Service News

Prevention of F.O. Solenoid Valve Installation Mistake

Solenoid valve of Normally Open (N.O.) is painted red.

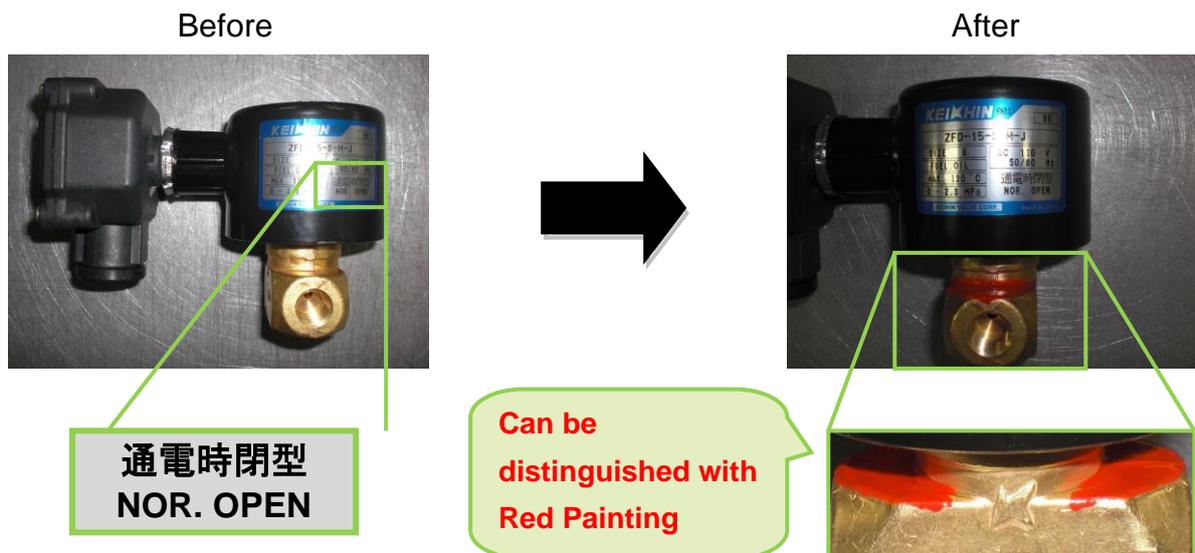
There was serious accident before that Normally Open (N.O.) and Normally Close (N.C.) was installed wrongly on type HB boiler at F.O. solenoid valve replacement. Although name plate is printed in both of Japanese and English, there are some cases that it can not be distinguished because coil part with name plate is taken off at installation and replacement, or difference of appearance can not be noticed and it is installed wrongly.

As prevention of these trouble, valve body of Normally Open (N.O.) is painted **Red** to distinguish Normally Open (N.O.) and Normally Close (N.C.) on valve itself.

*Solenoid Valve (Type; ZFD-15-H-J) of Normally Close (N.C.) has no change.

We would like you to order spare parts with new parts code.
